Existing SID: MID 4F 3G 3J 3K

Proposed SID: MAXIT 1F 1G MODMI 1J 1K (MID SIDs may or may not be retained in AIP, not flightplannable, restricted circumstances)

SID Truncation Sponsor Details:

Appendix 2: EGLL Aerodrome AIP amendments (assuming either *Option 3 Swap* or *Option 4 Hybrid*)

NATS PDG Draft Chart v8.0, rev 3, 2019

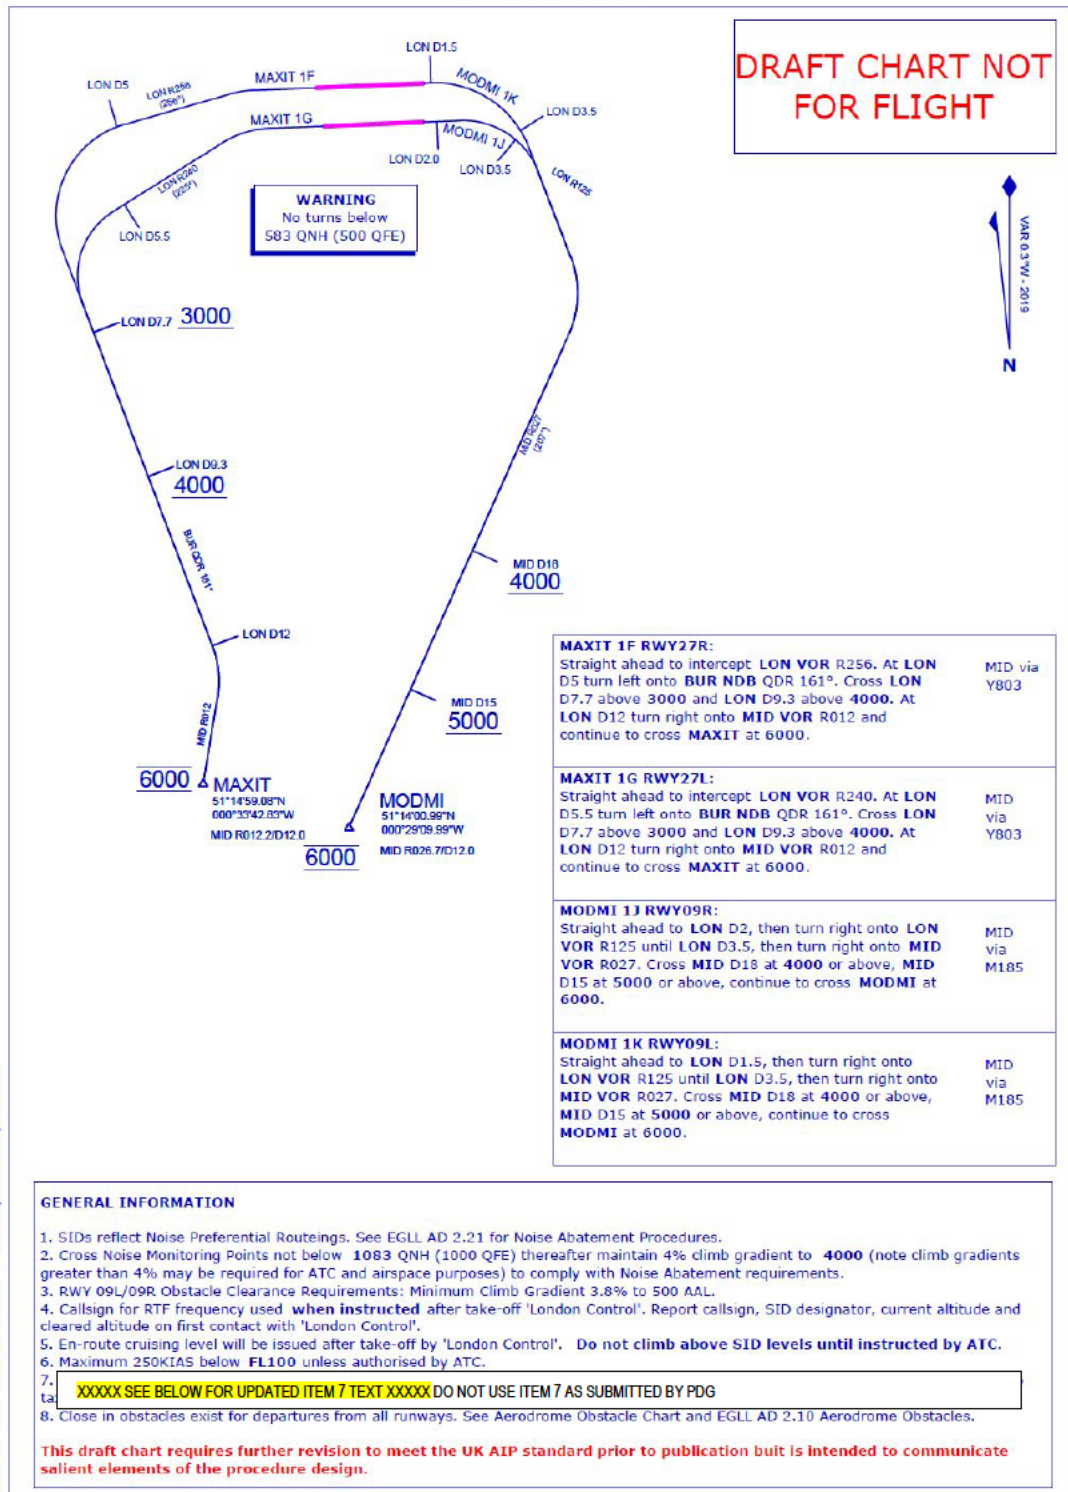
The MAXIT/MODMI sketch is attached on the next page.

If *Option 3 Swap* is approved, **replace** all AD 2.EGLL-6-2 content with MAXIT/MODMI SID plate (next page)

If *Option 4 Hybrid* is approved, **add** new MAXIT/MODMI SID plate (next page), numbered 6-8. **Also retain MID EGLL-6-2** but add **new General Information item**, at the top of the list in EGLL-6-2 all in bold, above the NPR item: **1: Not available for flight planning**. Renumber subsequent items accordingly.

Update item 7 of the PDG draft chart:

7. Flight crew of aircraft unable to meet SID climb restrictions must inform Heathrow Delivery prior to pushback. Restrictions/delays may apply.
